# TN-USB-FX-01 Manual Update

## Driver Installation Note - Change “Speed and Duplex” to “100 Mbps Full Duplex”

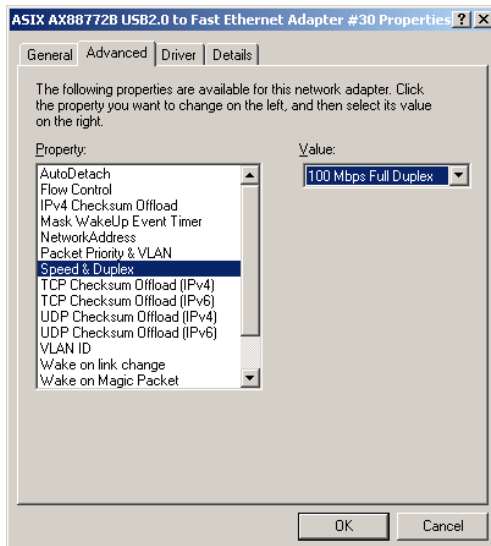
After you successfully install the driver, the TN-USB-FX-01 will work properly for a short time. To ensure continual operation, you must change the “Speed and Duplex Property Value” as described below.

2. Select and right click the “ASIX AX88772B USB to Fast Ethernet Adapter” (the name of the chipset / manufacturer). The General tab displays the message “*Windows has stopped this device because it has reported problems. (Code 43)*”.
3. Select “Properties” and then select the “Advanced” tab.

4. At the “Speed and Duplex Property Value” dropdown, change the Ethernet link speed from “Auto Negotiation” to “100 Mbps Full Duplex”.
5. Click the **OK** button.
6. Unplug and replug the TN-USB-FX-01. The device will now run properly.
